Access Compliance Report Public Rights-of-Way (Curb Ramps)

Main Street: SYLVANOAK_WAY Cross Street: FALABELLA_DR Location: NE

ADA ID: RPRK211112145844 Ramp Type: Type 4 - Parallel Initial Pass/Fail: Fail Overall Compliance: No Severity Score: 2

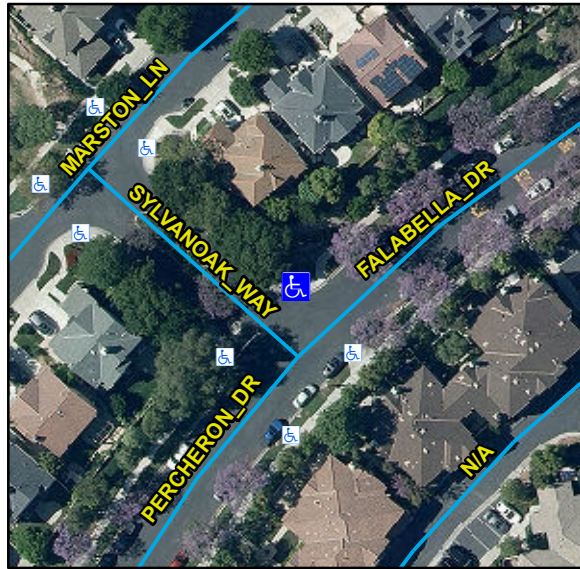
R304.2.2, R204.3, R304.5.3, STD 1115

Remove & Replace Curb Ramp With Two New Directional Ramps or Equivalent.
